Service Campaign Bulletin

SB-10057109-4627

Campaign No. 2014090006, October 2014

SUBJECT: **Model 197 (SLS-Class), Model Year 2014**
Check Power Steering Line Spacing, Correct if Necessary

Figure 1

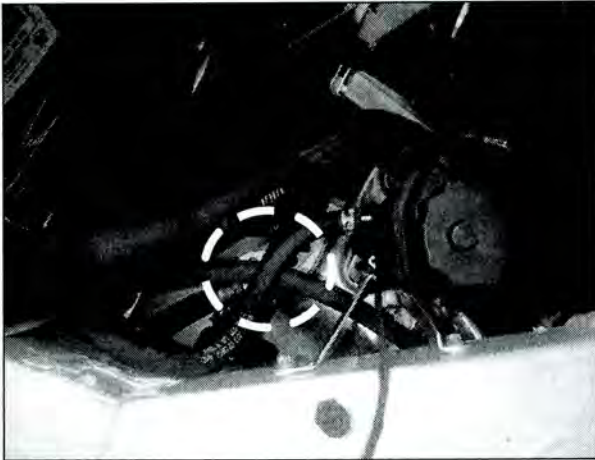
1.  Check minimum distance and condition of power steering lines (Figure 1):

- If minimum distance is at least 10 mm and line is **not** damaged (OK): Procedure is complete.
- If Minimum distance is **not** at least 10 mm (NOT OK) and line is **not** damaged (line OK): Proceed to step 3.
- If minimum distance is **not** at least 10 mm (NOT OK) and the line **is** damaged (line NOT OK): Proceed to: Steps 2 and 3.

Figure 2

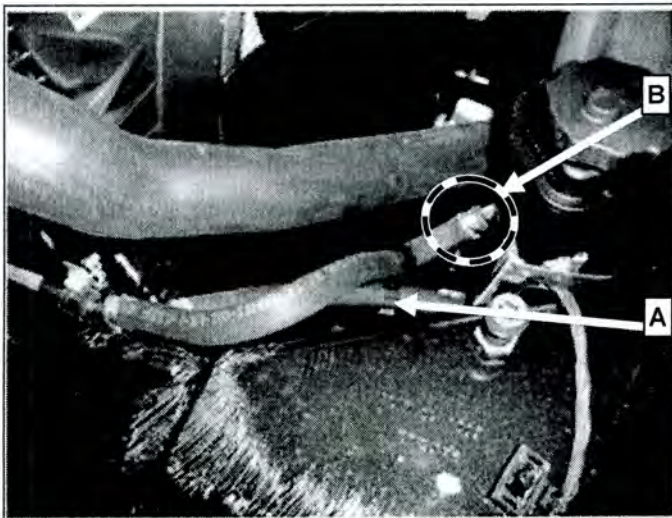
- Remove only left air filter housing (step 4), do not remove bolts from diagonal strut (step 5).
 - Do not perform steps 21-30.
 - Be sure to check power steering fluid level and correct if necessary (shop supply).
3.  Install spacer (A, Figure 2).

**Note:** The hose clamp (B) on the power steering fluid reservoir may need to be loosened and the steering line turned until the minimum distance is ensured (Figure 2). Be sure to lock hose clamp (B), replace clamp if necessary.
